4F27E Ford Automatic Transmission

PRODUCT BULLETIN

Updated Rear Cover

UPDATED COOLER PORT SHOWN IN RED

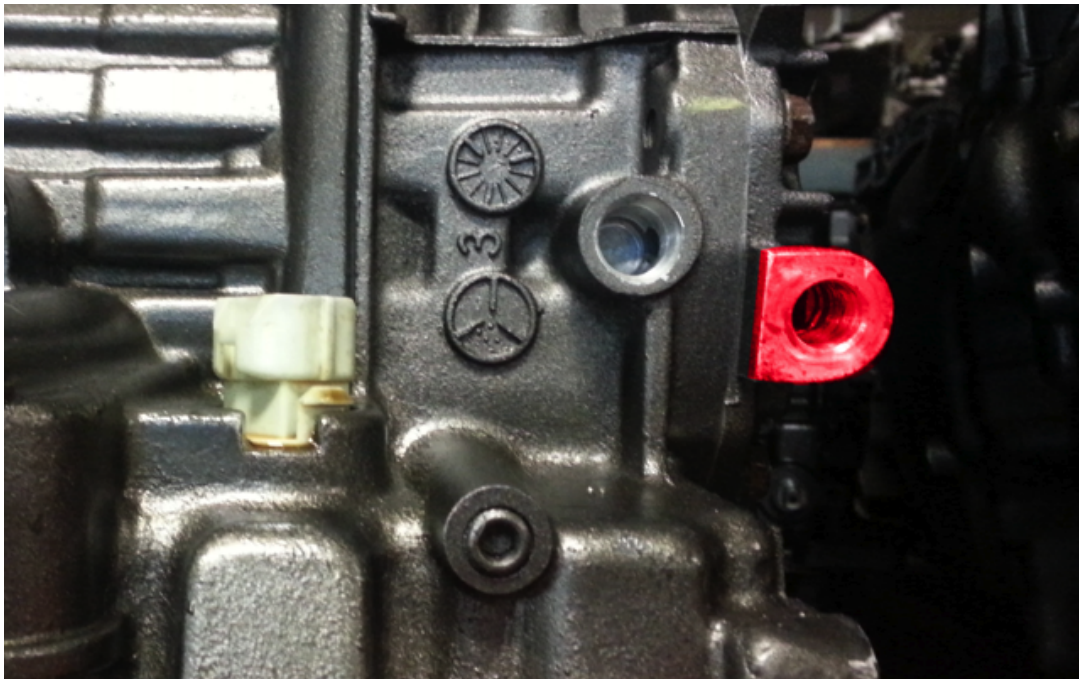
Due to premature rear cover failures in most Mazda applications, all of our remanufactured 4F27E (FN4A-EL) transmissions are updated with the improved Ford-designed rear cover.

The cooler return line must be relocated from the case to the end cover. During remanufacturing, the transmission is internally updated and the factory cooler line hole in the case is **permanently** sealed – all Ford applications will remain unmodified. Mazda units are updated to accept Mazda factory cooler line fittings (M14 x 1.50).

If you install the return cooler fitting into the original case location there will be no lubrication provided to the rear of the transaxle and immediate failure will result and is **not** covered under your warranty.
